Application No. : 10/020,544

AMENDMENTS TO THE DRAWINGS

REMARKS

Fig. 7 (EXHALATION)

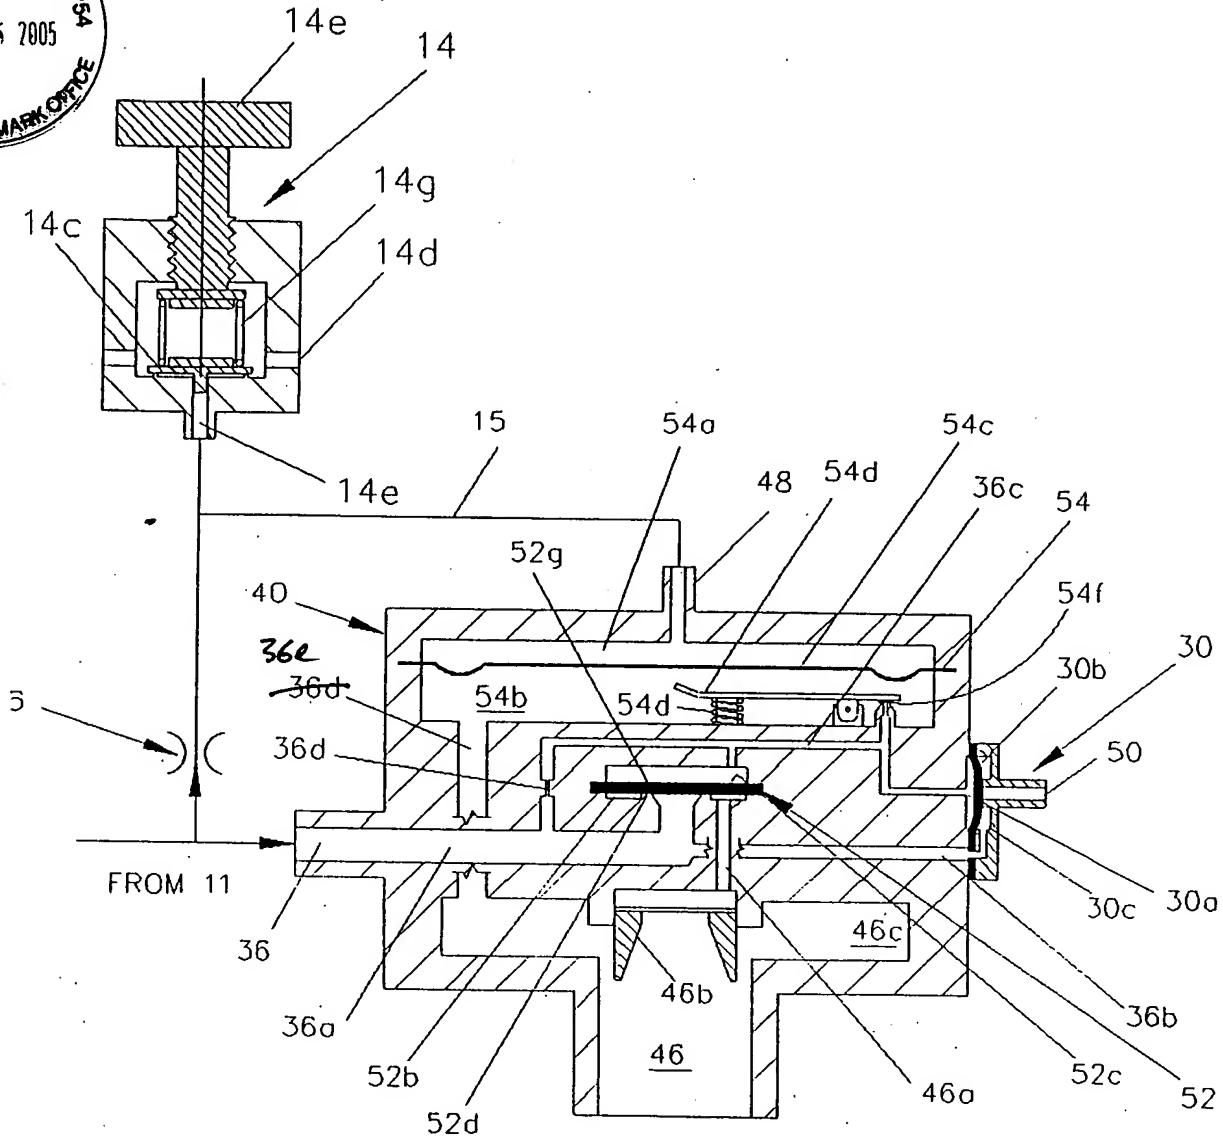
The attached sheet of drawings include changes to FIG. 7. This sheet includes FIG. 7 and replaces the original sheet including FIG. 7. In FIG. 7, the upper 36d reference number is replaced with 36e.

FIG. 7 has been amended according to the Examiner's comments to the Notice of Allowance. One of the "36d" reference numbers has been corrected to read -- 36e --. Support for the amendment is found, for example, in the specification on page 10, lines 19-23 as modified in the Preliminary Amendment filed May 2, 2003, page 4 ("Passageway 36e connects the lower chamber 54b of valve 54 to an outlet chamber 46c of the demand valve, which chamber extends above the outlet port and circumferentially around a nozzle 46b."). No new matter is entered by way of this amendment.
